## **RESPONSES TO PUBLIC COMMENTS RECEIVED DURING PUBLIC REVIEW AUGUST 9, 2018 – SEPTEMBER 24, 2018**

### **Response to comments received from Valle de Oro Community Planning Group**

Response to Comments  
PDS2015-MUP-15-029  
PDS2015-ER-15-08007

# RANCHO SAN DIEGO SPECIFIC PLAN (DETAIL)

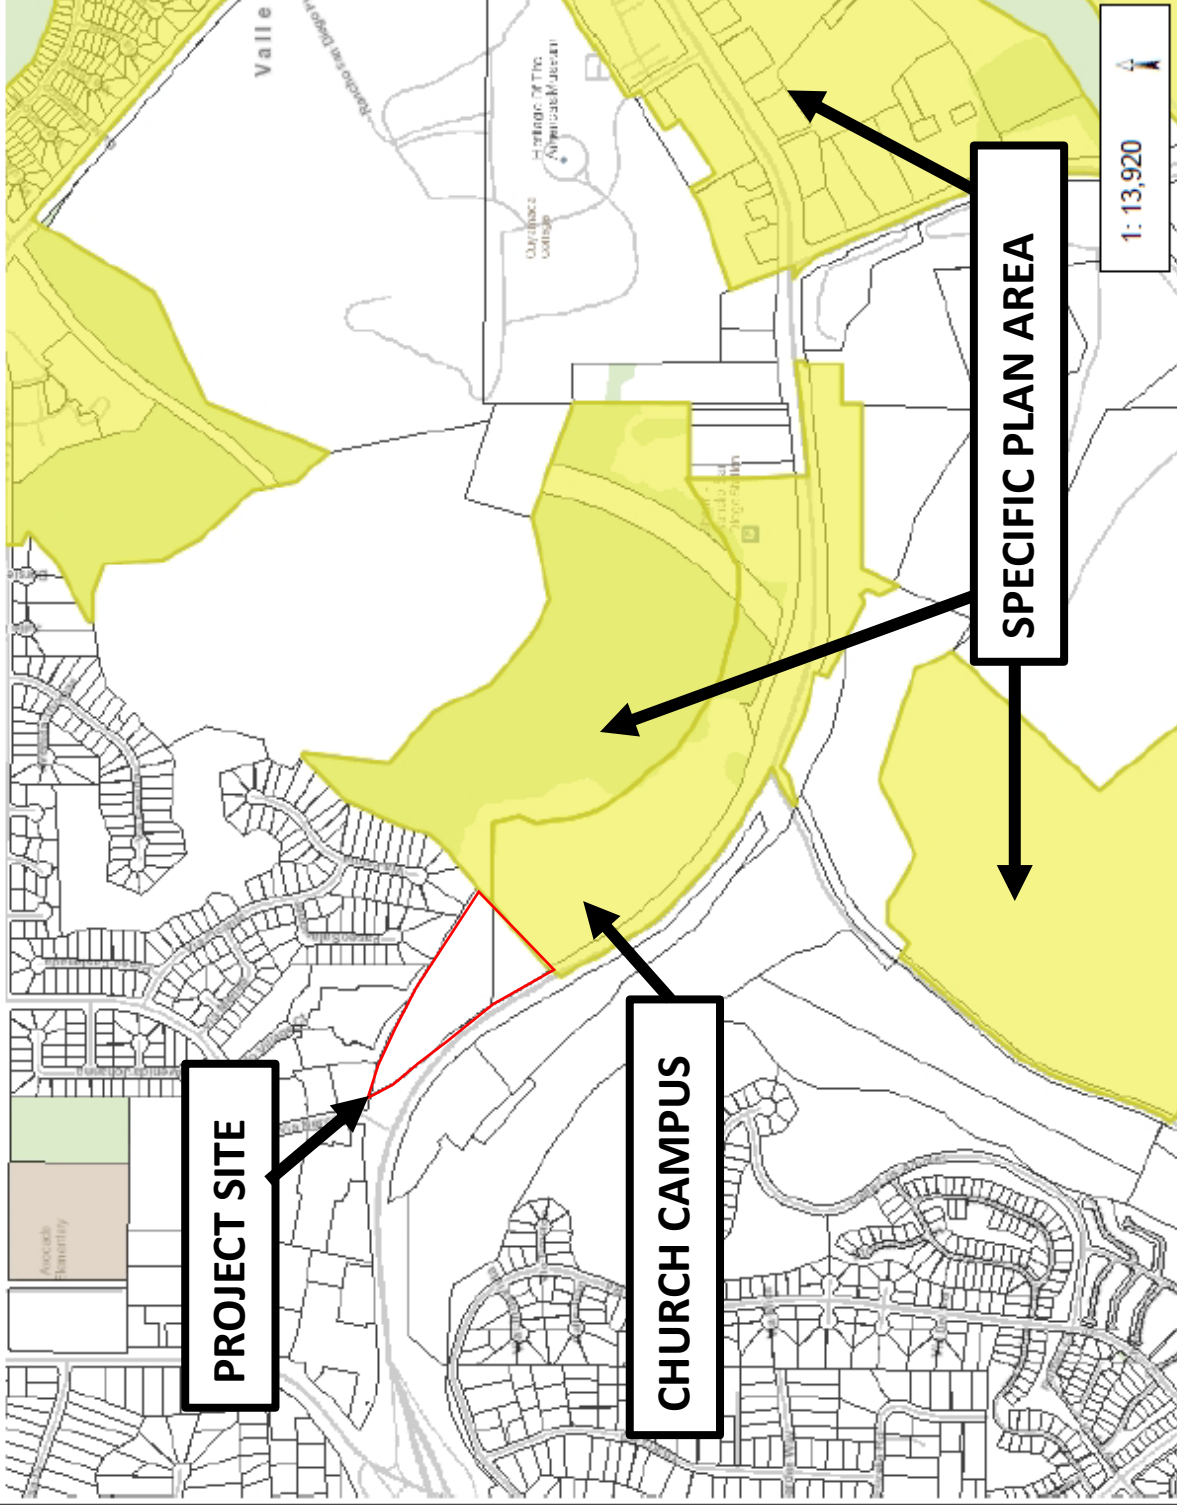
- A-9 The County appreciates this review and comment from the VDOCPG in its letter dated September 9, 2018. The County acknowledges VDOCPG's concern regarding the boundaries of the Rancho San Diego Specific Plan Area.

The comments from VDOCPG resulted in a staff re-examination and clarification regarding the location of the Project site in relation to the Rancho San Diego Specific Plan boundaries. This included re-examining: the original Rancho San Diego Specific Plan SP 79-05 (approved January 16, 1980); the Environmental Impact Report for the original Rancho San Diego Specific Plan (certified September 27, 1979); Rancho San Diego Specific Plan Amendment SPA87-001 (approved March 6, 1988); the Final Environmental Impact Report for Rancho San Diego Specific Plan Amendment SPA87-001 (certified March 6, 1988); and Rancho San Diego Specific Plan Amendment SPA13-001 (approved December 4, 2013); and GIS data information. This research conducted by County staff reaffirmed that the 8.9 acre Project site is not located within the Rancho San Diego Specific Plan area. (See Responses to Comments Appendix A.) It should be noted that the existing church development is located within the Rancho San Diego Specific Plan area and the formerly proposed east mitigation parcel also is located in the Rancho San Diego Specific Plan. However, these areas would not undergo any land use changes from implementation of the Project and do not require any Specific Plan Amendments. Therefore, the Project site is not located within the Rancho San Diego Specific Plan. The MND does not analyze the Rancho San Diego Specific Plan because it is not located within the Specific Plan area and a Rancho San Diego Specific Plan Amendment is not required. No changes were made to CEQA documentation as a result of this comment.
